HDM Halswell Flood Model

Model Status Report

Prepared for Christchurch City Council

Revision N°	Description	Date
A	First release to accompany delivery of Existing Development 2016 model.	09/12/2022
B	Updated to reflect Existing Development 2021 model – at Peer Review stage.	16/12/2022
C	Updated for delivery of 2021 model	20/10/2023
D	Updated for delivery of 2024 model	08/12/2025
E	Updated based on DHI and Council Comment	20/02/2026

Figure 6 - manhole losses. Red = km50 mouse classic, blue = km25 weighted inlet energy. Green shows where inlets are located. Based on the methodology suggested if the node is not linked and not a flow through node it should be set to km25 weighted inlet energy.

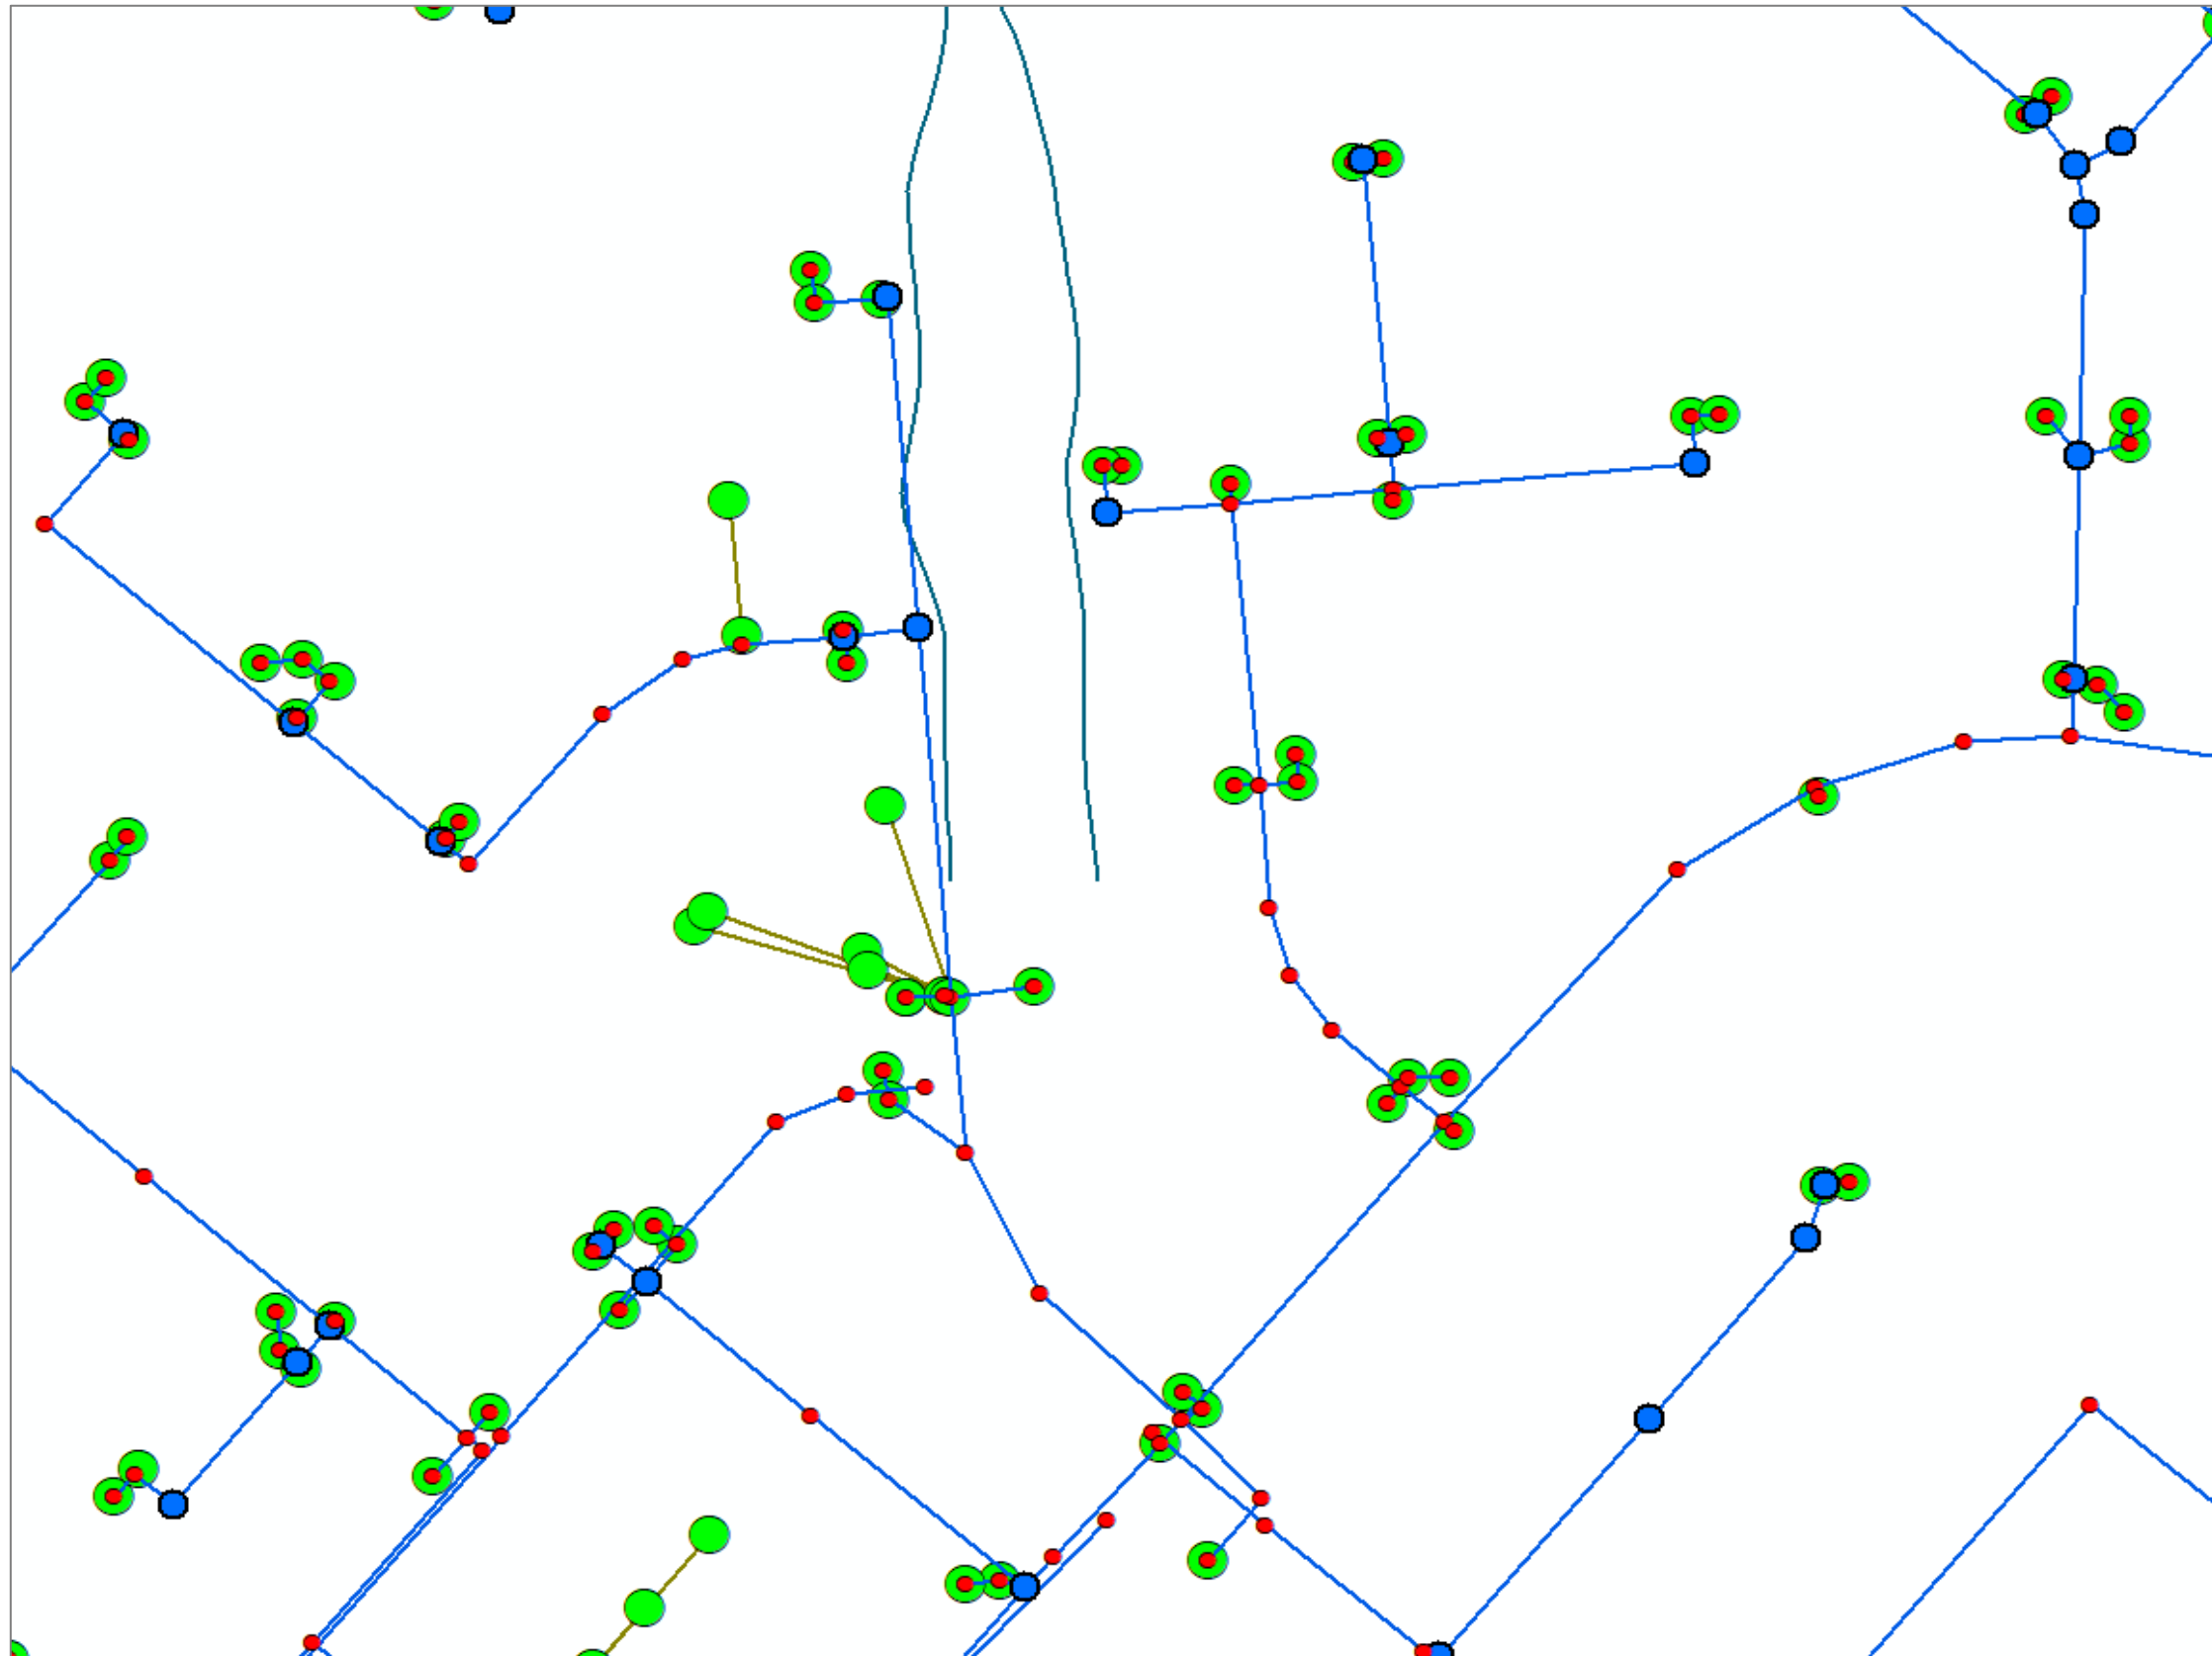
for example where you see red points with no green, this is incorrect and they should be blue instead
